**City of Beaufort Department of Planning & Development Services  
DESIGN REVIEW BOARD (DRB) APPLICATION FORM**

**Project Name:** Harris Teeter at Lady's Island

**CITY OF BEAUFORT  
DESIGN REVIEW BOARD  
Staff Report  
Meeting of February 11, 2016**

**Case Number:** 16-01 DRB.2  
**Project:** Harris Teeter on Lady's Island  
**Property Address:** 163 Sea Island Parkway – NE Corner of Hwy 21 & Hwy 802  
**Parcel #:** R123 015 000 0587 0000; R200 015 000 0592 0000  
**Zoning:** General Commercial  
**Design District:** Lady's Island Village Center Design District  
**Type of Review:** **Conceptual Review – New Construction**

Proposed Site Plan

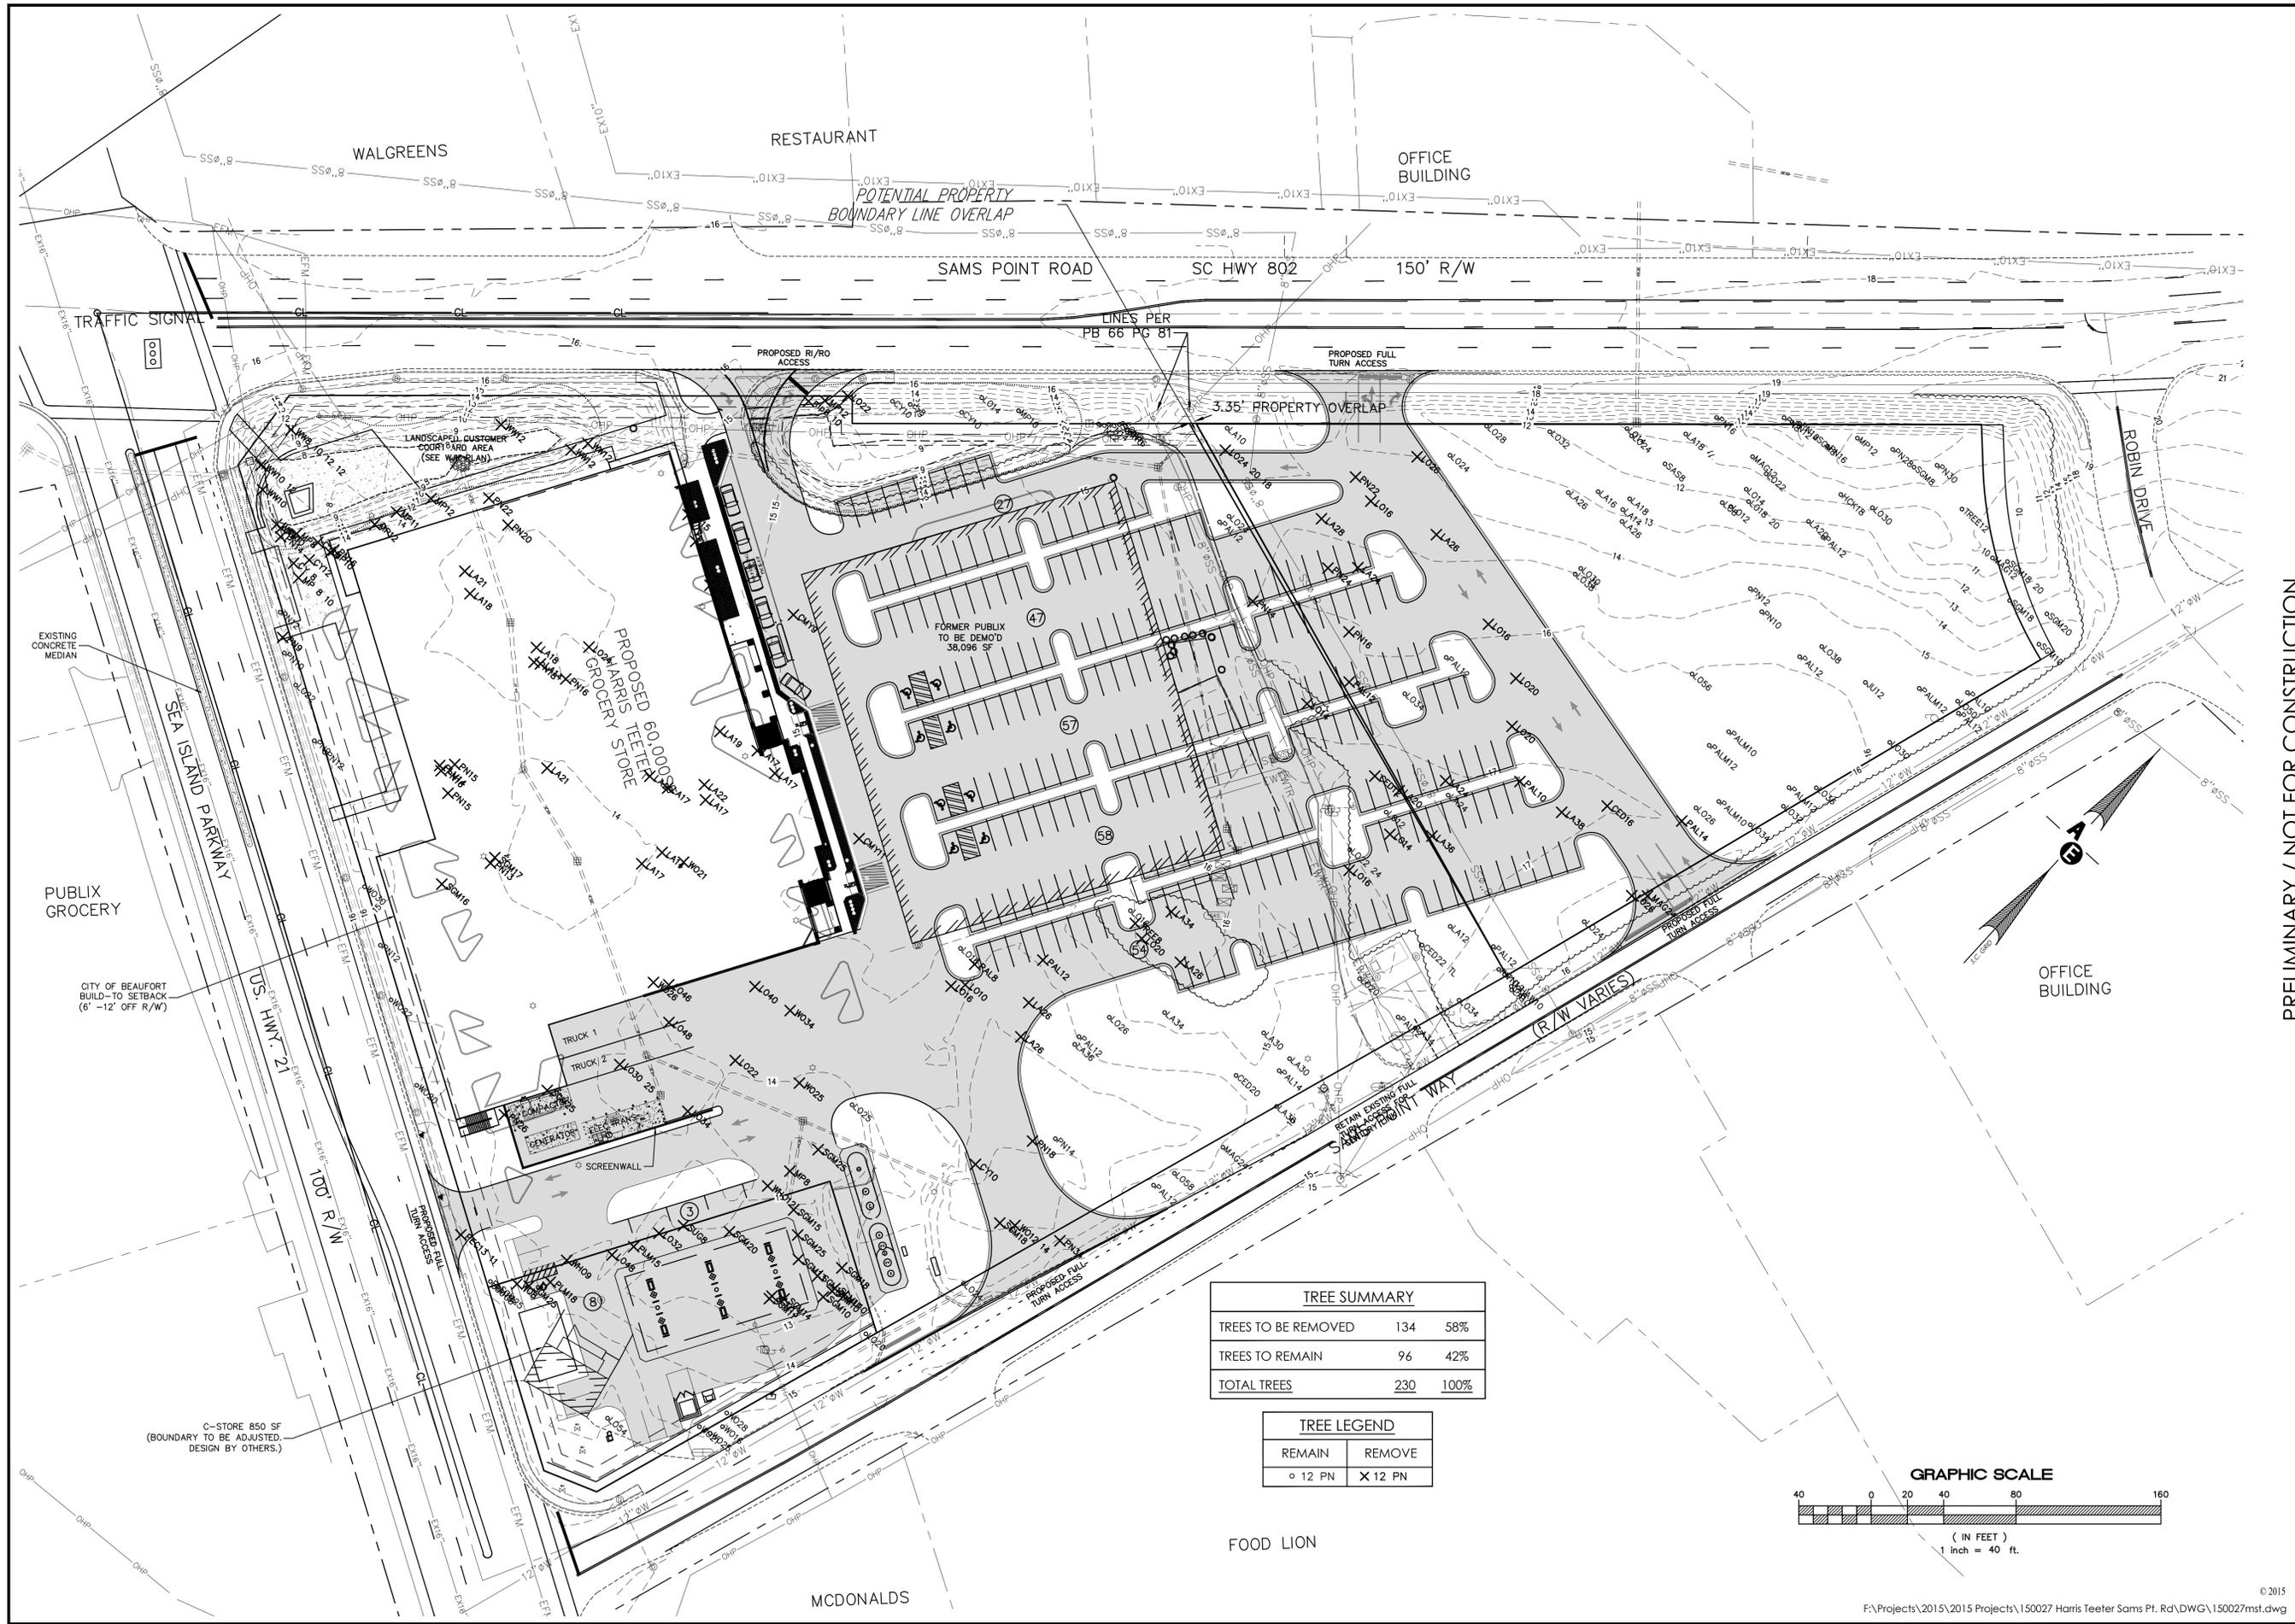
Site: The narrative submitted for the variance request states that the building is pulled back at the intersection to accommodate future turn lanes. However no study has been prepared prescribing these and stating that if they are needed, how much room they would require. A traffic impact analysis will be required and decisions regarding the building placement and whether or not a variance from the build-to line is appropriate should be based on data and approved mitigation techniques.

Trees: a significant number of trees are proposed to be removed in the front of this property. Staff feels that this is inappropriate given the quality of streetscape that is being proposed in their place. A formal tree survey will be required and some adjustments in the site plan may be required to accommodate existing trees. A certified arborist report will be required for any grand trees (>24”) to be removed OR retained and impacted by construction.

Staff recommends that the DRB deny this application and recommend denial of the variance requests to the ZBOA. Alternatives should be studied that locate the building in a similar footprint as the former Publix, and either incorporate liner buildings along Sea Island Parkway

and Sam's Point Road, or reserve space for them in the future. The applicant should also investigate ways to retaining some of the existing significant trees, located in the front of the property. Other alternatives, as well flexibility within the zoning requirements, may be possible, but staff recommends neither the DRB nor the ZBOA approve any plans that do not at least meet the general intent of this Village Center District and the Civic Master Plan.
